THE POINTE AT WOLF CREEK
LOCATED IN THE SOUTHWEST QUARTER OF SECTION 22,
TOWNSHIP 7 NORTH, RANGE 1 EAST, SALT LAKE BASE AND MERIDIAN,
WEBER COUNTY, UTAH
JUNE 2021

Please see comment on second page. Address review will be submitted once I get clarification on how the unit numbering works.

MAIN LEVEL FLOOR PLAN

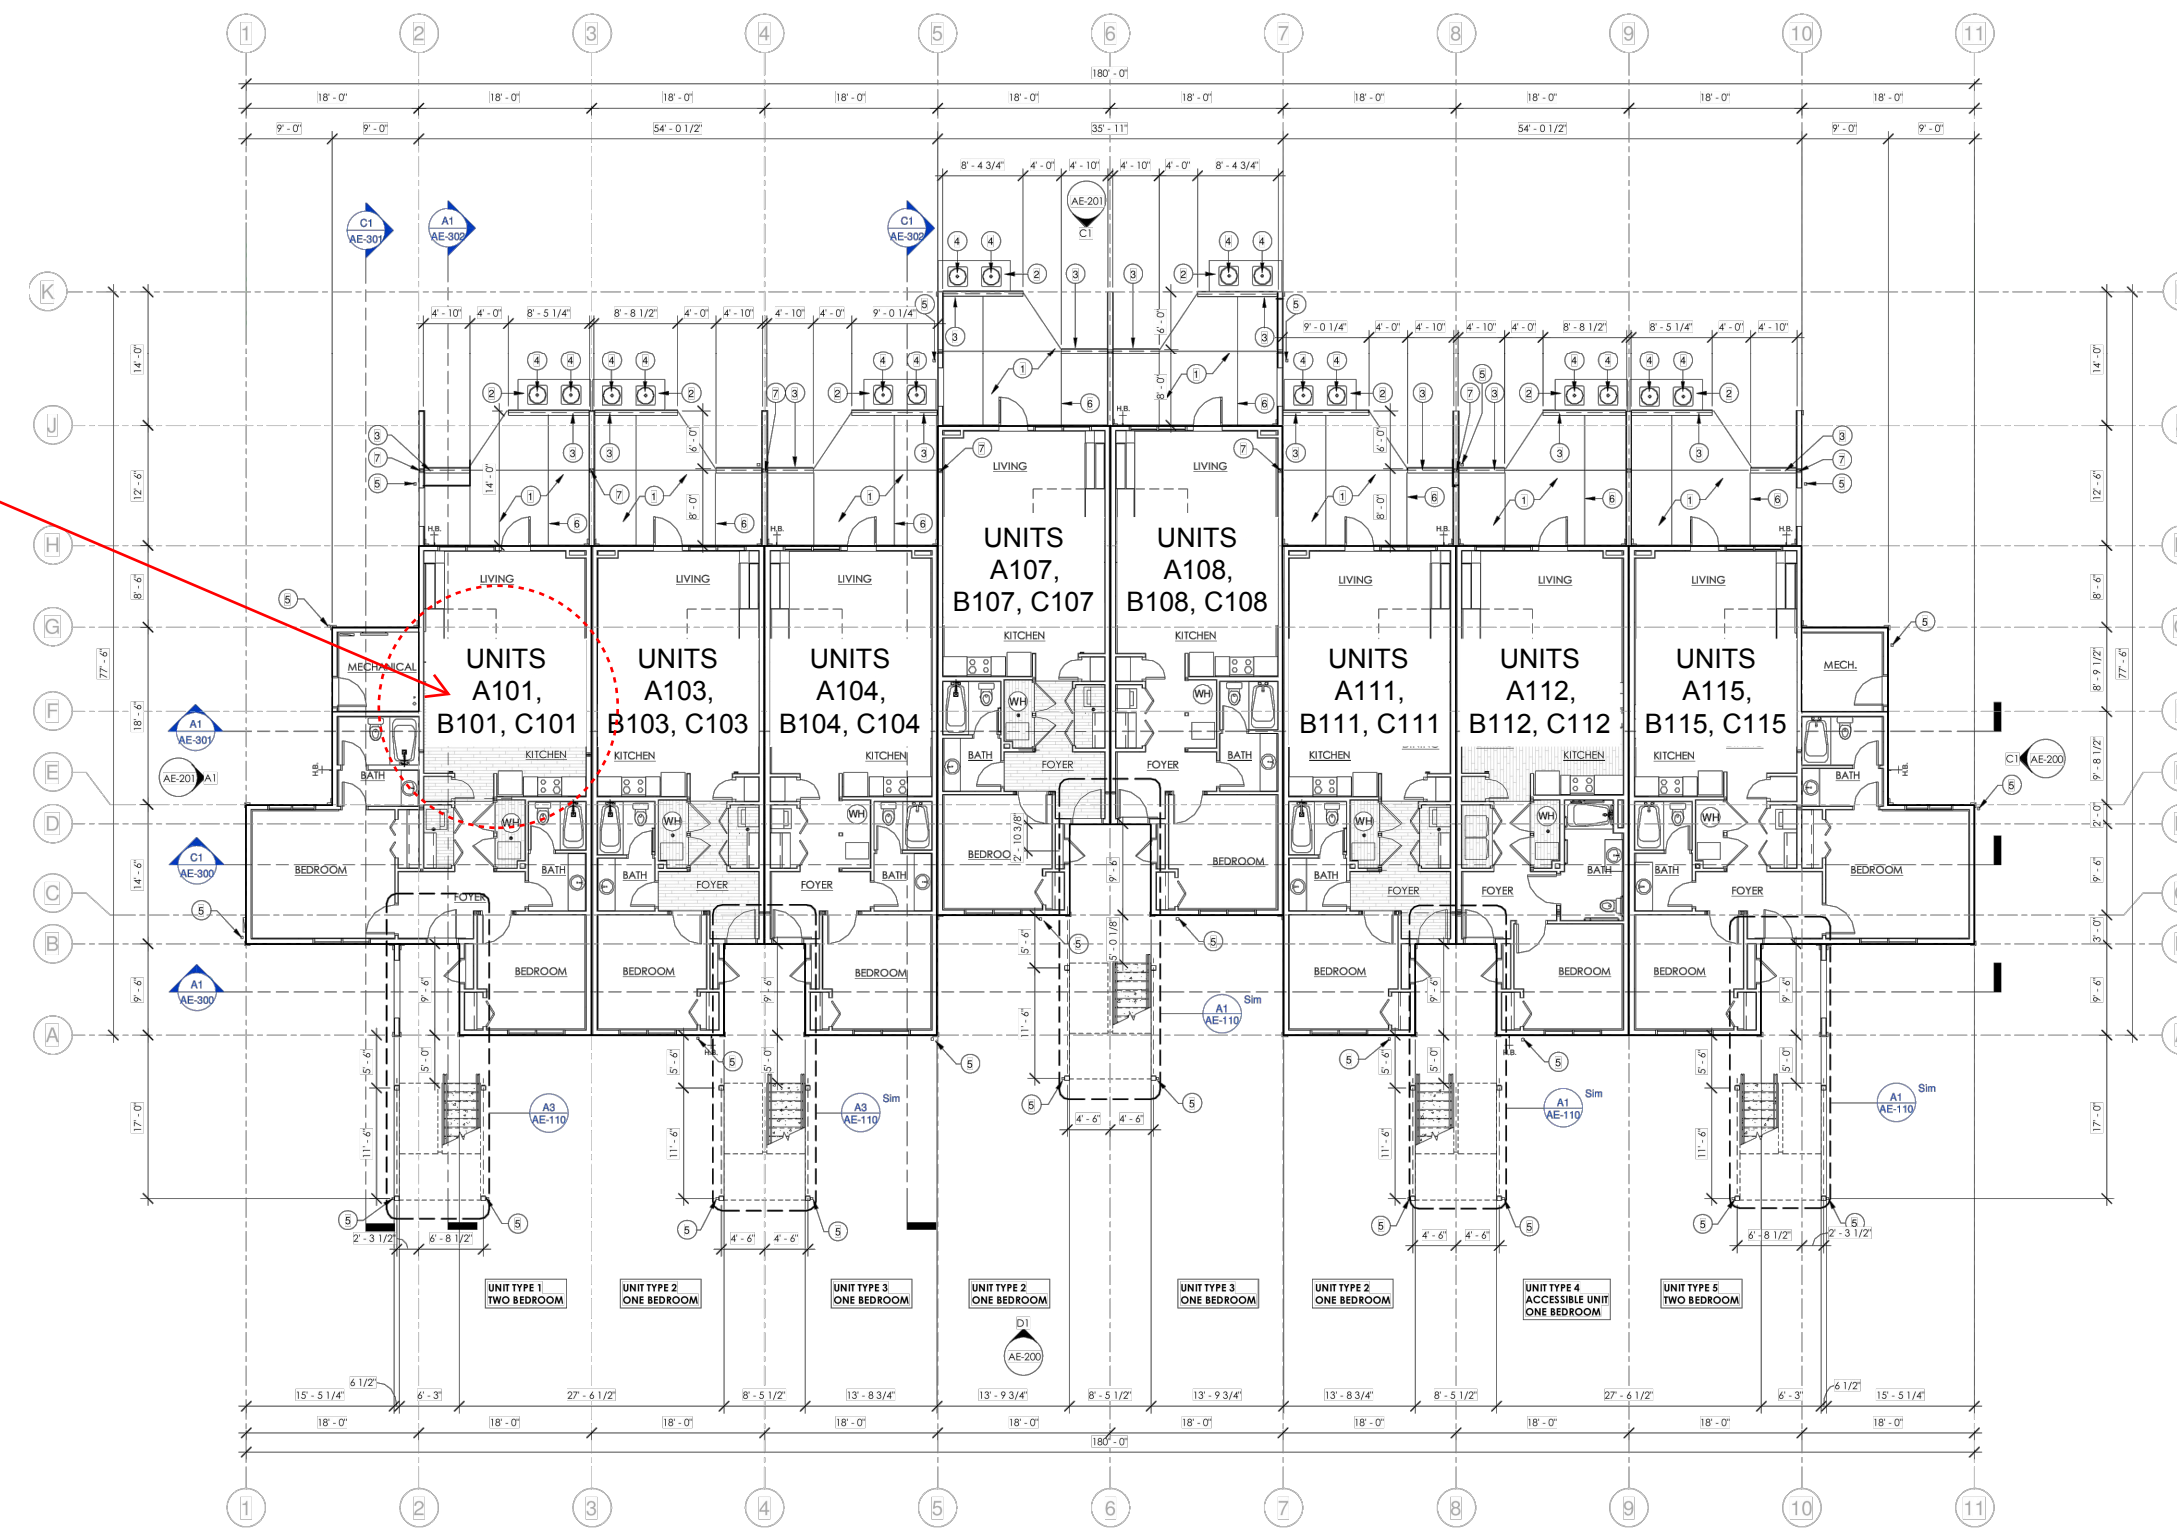
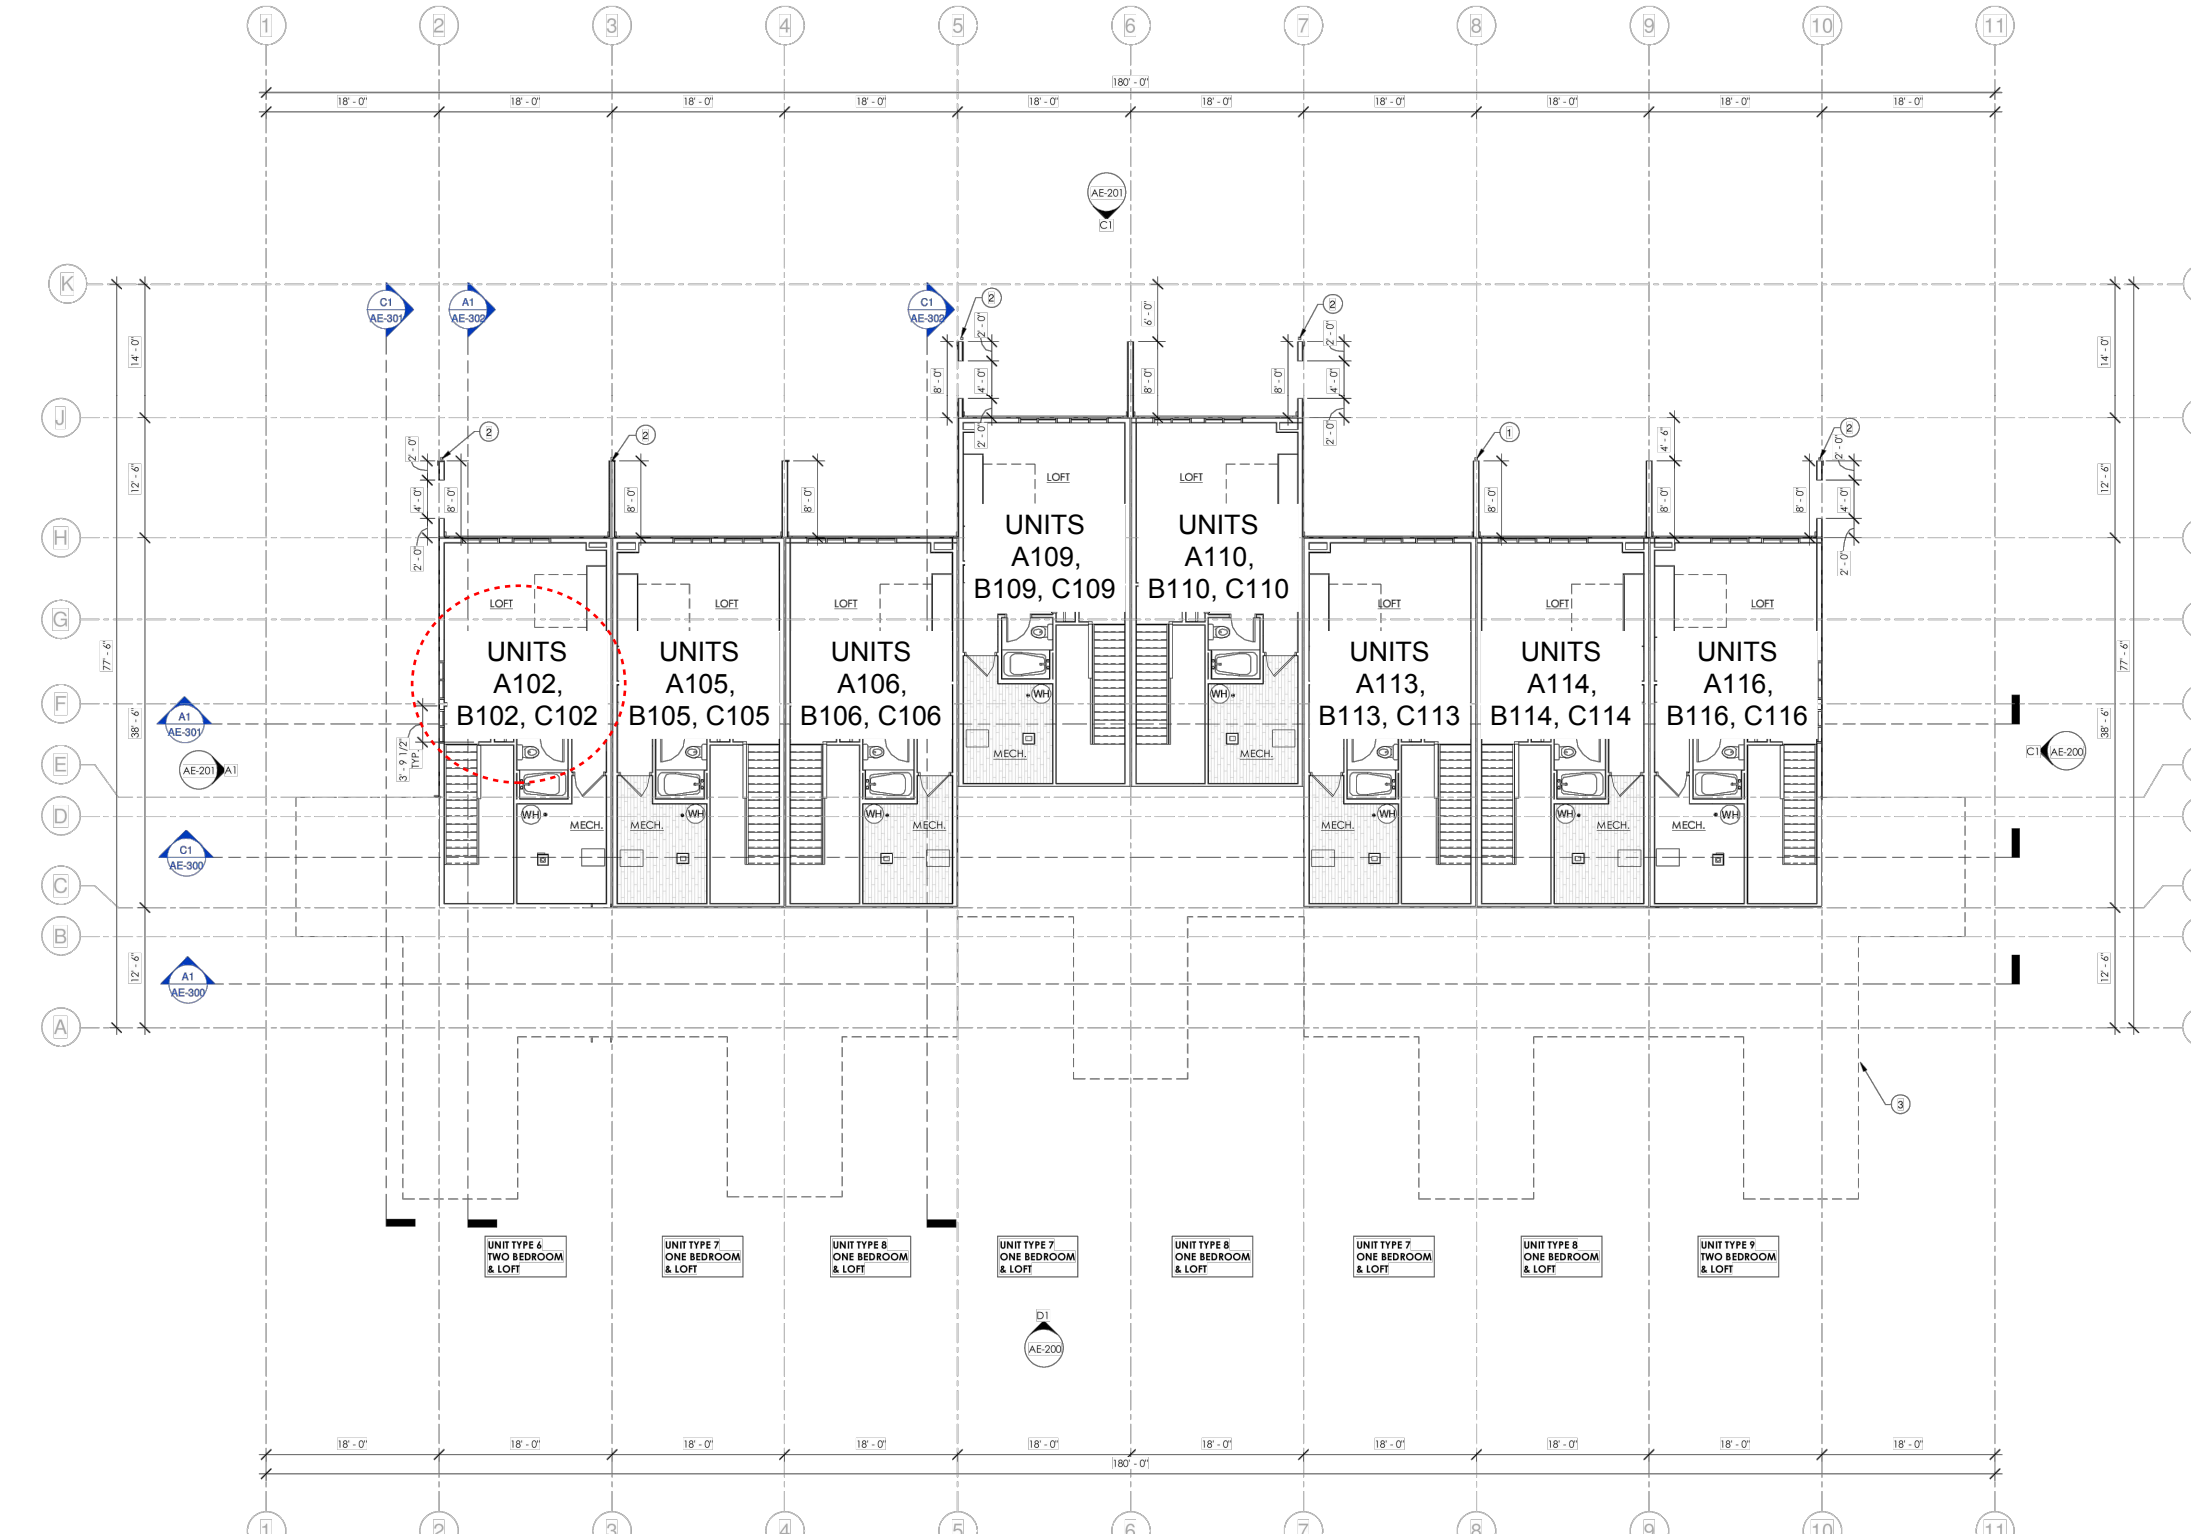
How does the numbering work? Each unit should be the same number.
